STAFF REPORT
(ONE-STEP FINAL PLAT)

CASE NUMBER: SUB 2002-97 -- HIS HELPING HANDS ADDITION

OWNER/APPLICANT: Central Christian Church – His Helping Hands, Inc., 2900 N. Rock Road, Wichita, KS 67226

SUB 2002-97 -- One-Step Final Plat of HIS HELPING HANDS ADDITION
October 3, 2002 - Page 3

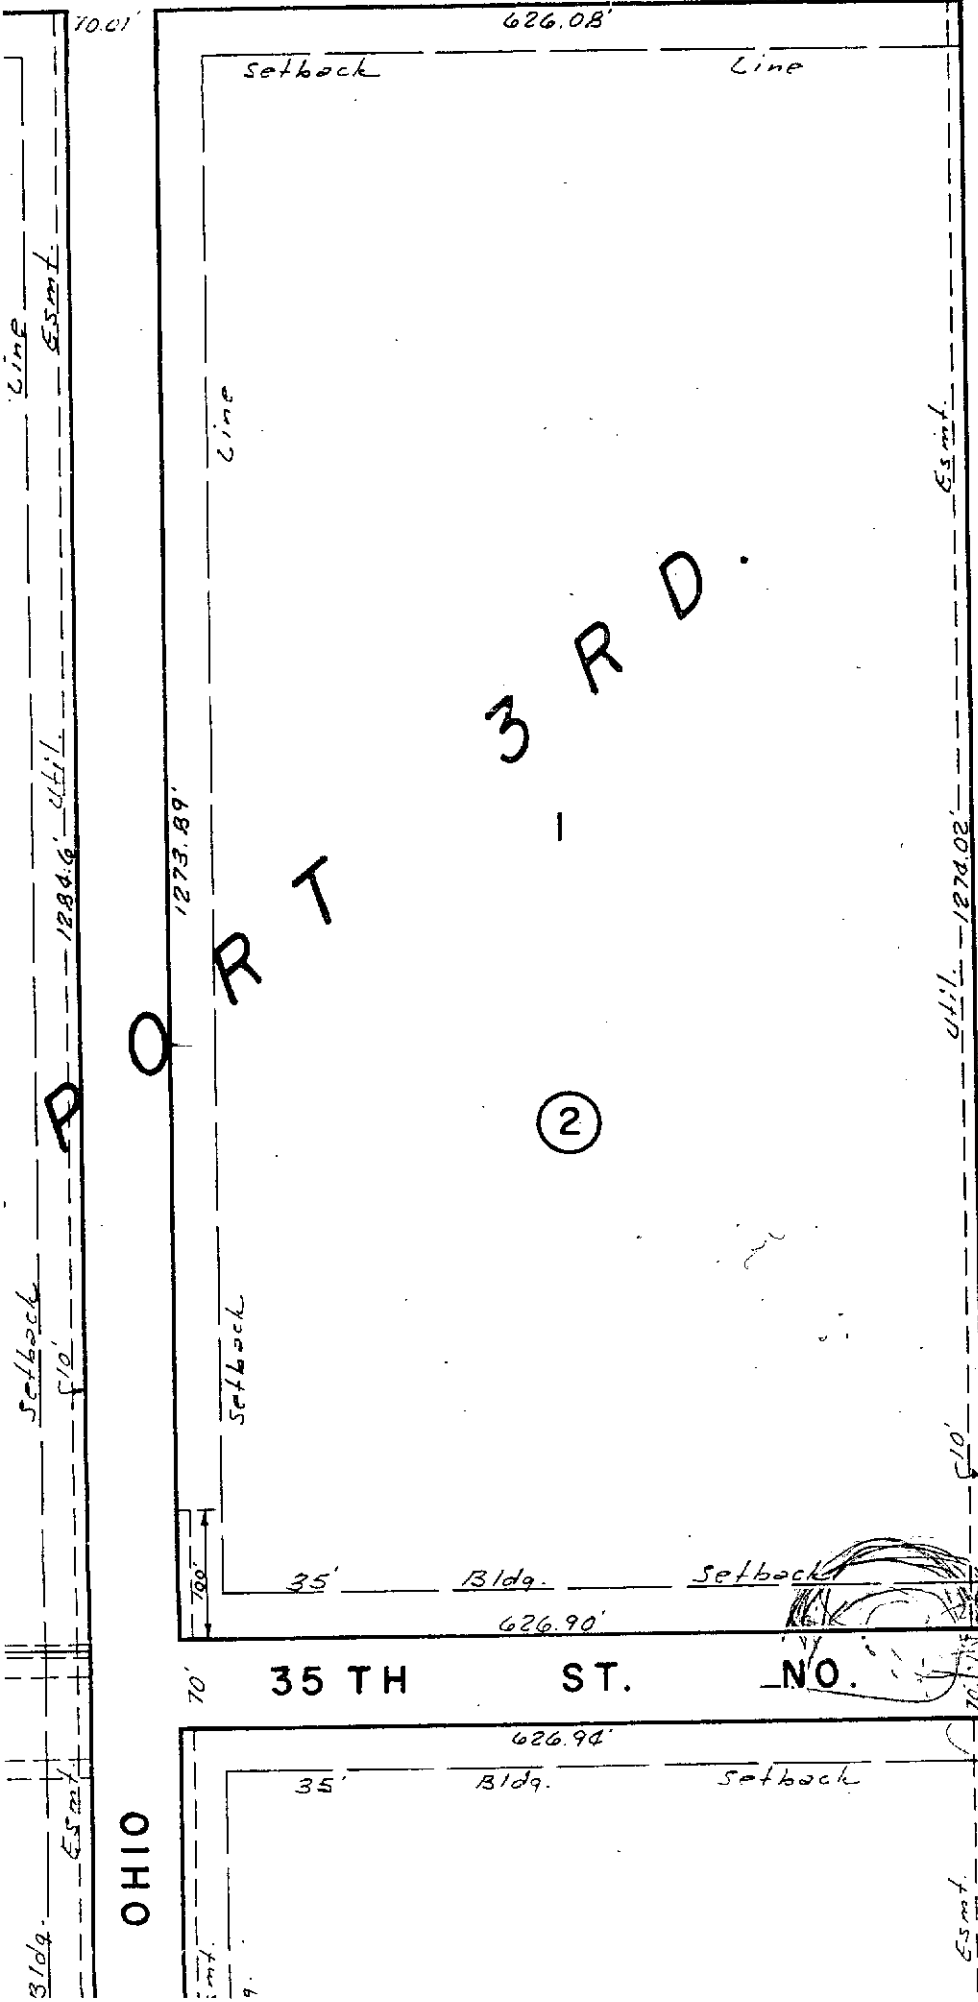
- D. The plat proposes two access openings along 37th St. **Traffic Engineering** has requested the westerly opening be right turns in/out only and be located along the west property line. The easterly opening should be located in alignment with Bridgeport across 37th Street. Cross-lot access should be provided to the abutting property to the west. Complete access control needs to be dedicated along I-135. Distances should be shown for all segments of access control. The final plat shall reference the dedication of access controls in the plat's text.

- E. **Traffic Engineering** has requested additional right-of-way along 37th St. North. The proposed Access Management Policy requires a 60-ft half-street right-of-way width along urban arterials. The plat's text shall note the dedication of the street to and for the use of the public.

- F. A petition should be provided for the paving of 35th St. North.
- G. **City Engineering/City Fire Department** needs to comment on the need for a dedication of right-of-way for a turnaround for 35th St. North.

- M. The 25-foot easement for the district court case needs location and description on the final plat.
- N. In the surveyor's certificate and the plat title, the plat name needs to be corrected.

- O. The NE section corner needs to be labeled.
- P. The described distance of 497.14 needs to be moved to the 35-foot right-of-way line.
- Q. The platlor's text shall include language that a drainage plan has been developed for the plat and that all drainage easements, rights-of-way, or reserves shall remain at established grades or as modified with the approval of the applicable City or County Engineer, and unobstructed to allow for the conveyance of stormwater.
